Client: Sidmouth YMCA	
Address: Mill Street, Sidmouth, EX10 8DF.	
Project: Proposed Window Replacement	
Drwg: East Elevation (PROPOSED)	
Scale: 1:50 @ A3	Date: Jan 2024
Drwg. no: 1271/24/13	Rev: A

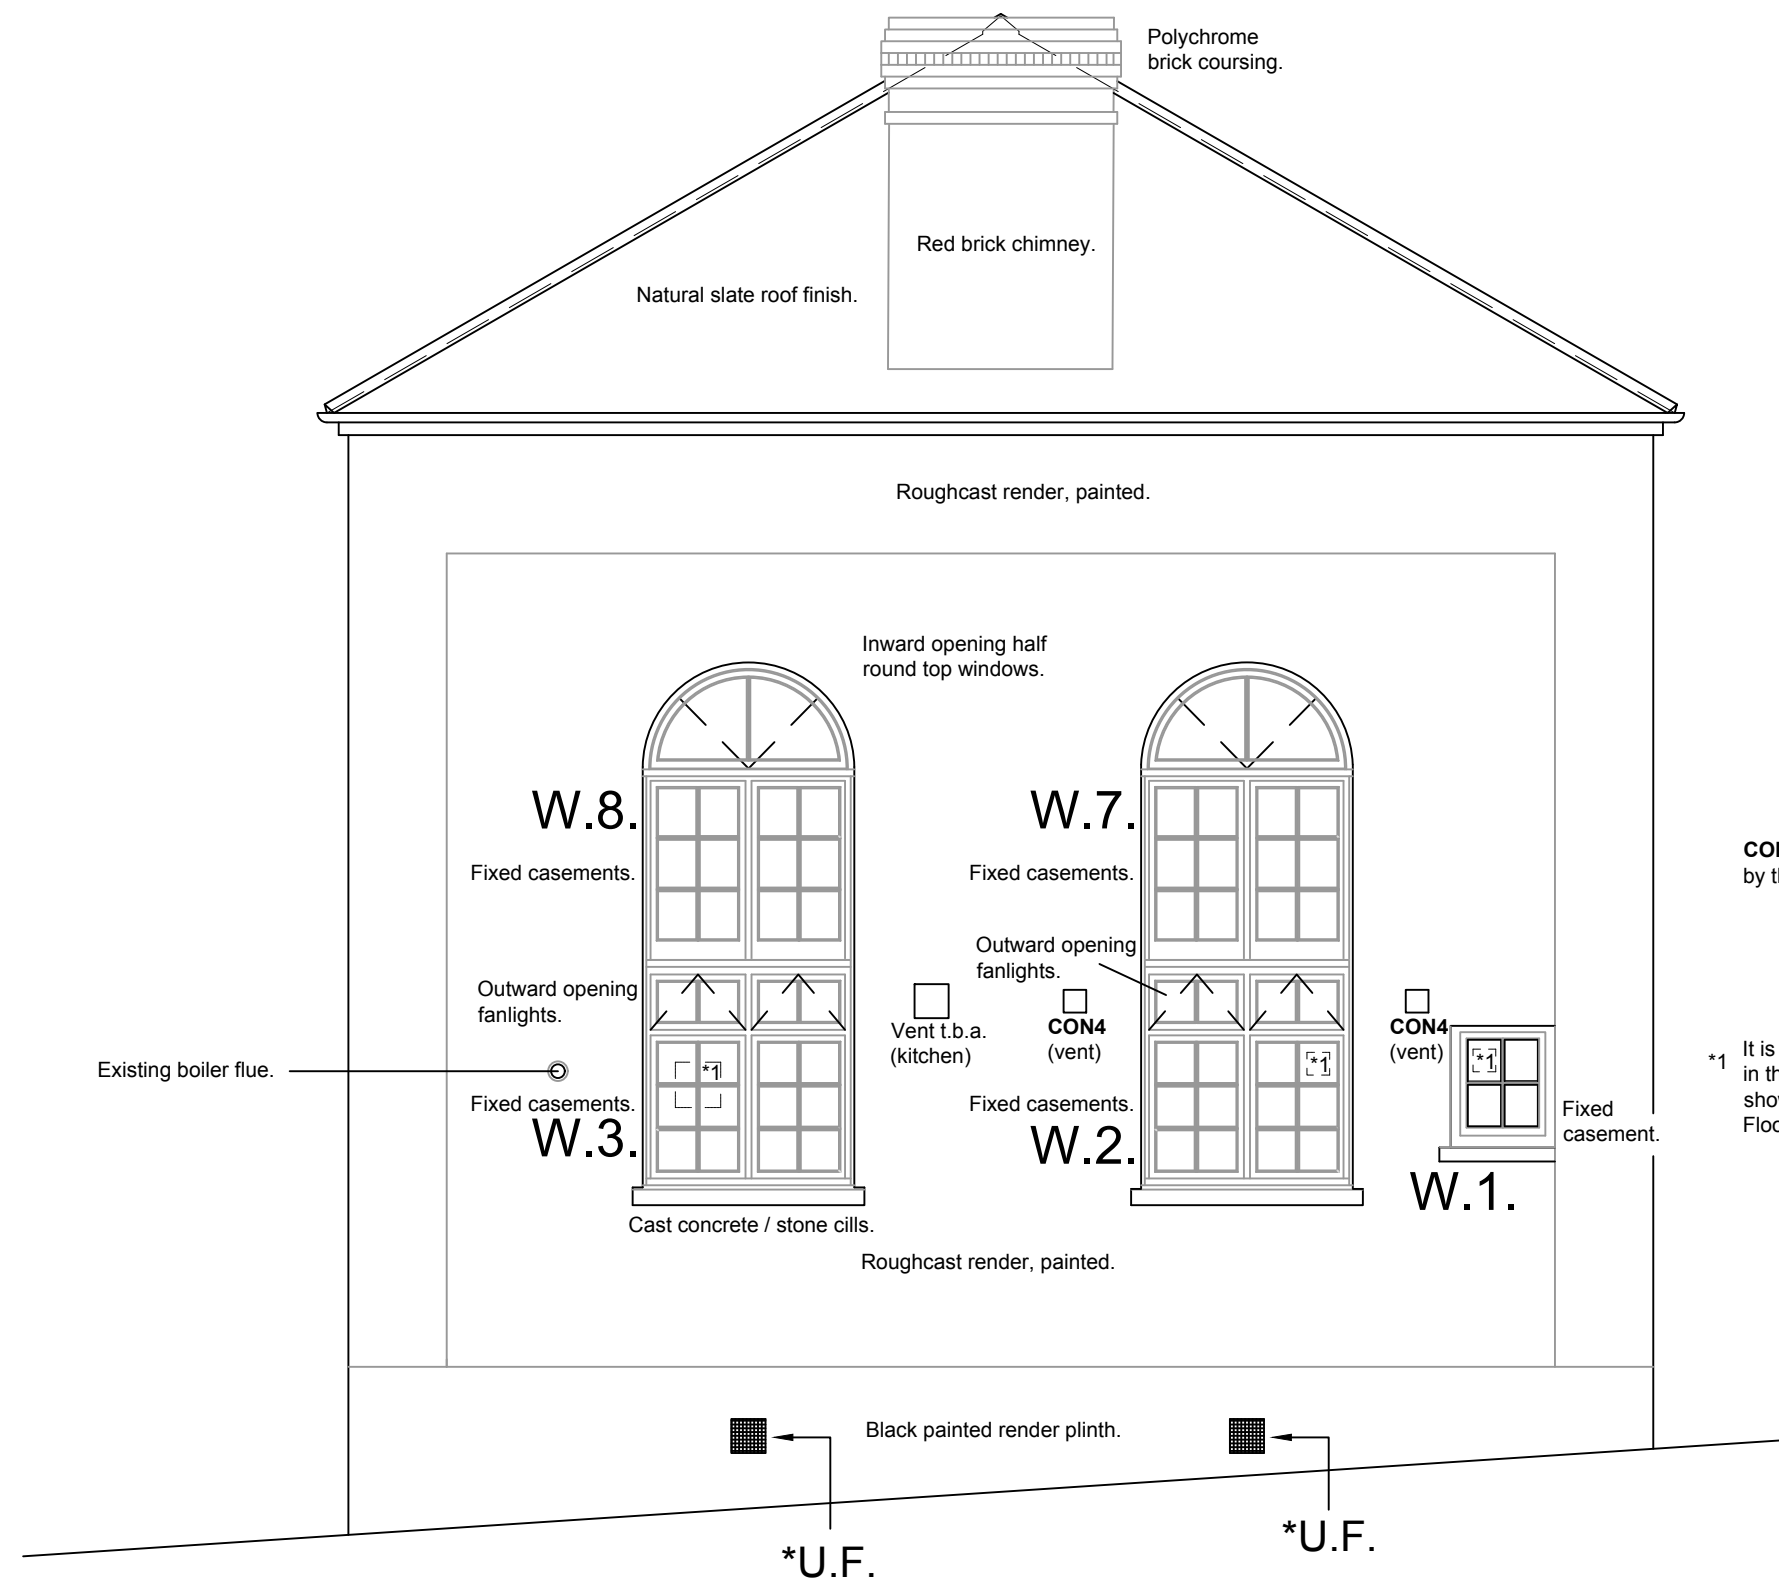
Revision	Date	Details
A	12-03-23	Mechanical ventilation added and under-floor thru wall vents added.

\*1 It is proposed to avoid having mechanical extract vents in the windows, with new mechanical extract vents now shown coming through the wall. Refer also to Ground Floor Plan drawing 1271-24-01.

\*U.F. = Proposed 225 x 225mm terracotta air bricks to ventilate under-floor void.
